ES_BMI7018

Errata sheet for BMI7018

Rev. 1.0 — 19 September 2024

3.1 ER1: Cell balancing switch fault monitoring

3.1.4.1 Workaround 1

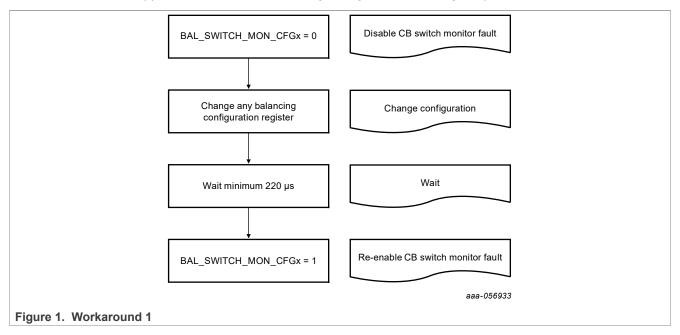
A balancing switch fault may be reported under the condition that the cell balancing stays activated or deactivated with a duration of typically 200 µs (min 190 µs, max 200 µs).

A 200 μs pulse may be caused by software access when changing configuration ...

Workaround 1: To be applied each time the balancing configuration is changed by software access.

Diagnostic: CB MOS switch diagnostic

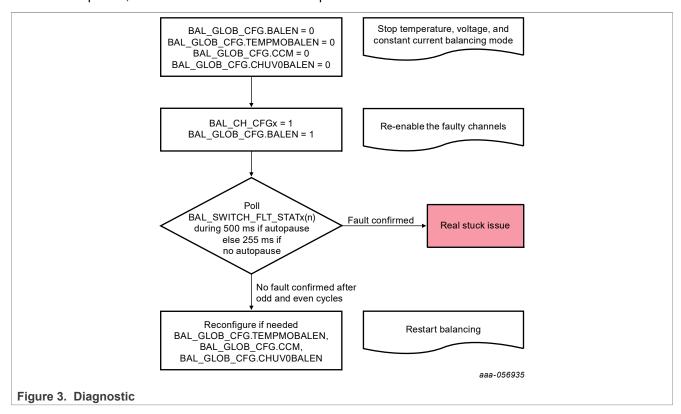
If a switch fault is reported, the customer must execute a diagnostic of the CB MOS for confirming the real stuck on or off. If the fault is not confirmed, the balancing will continue as expected.

If a fault is reported, the customer must execute the procedure described to confirm the result.
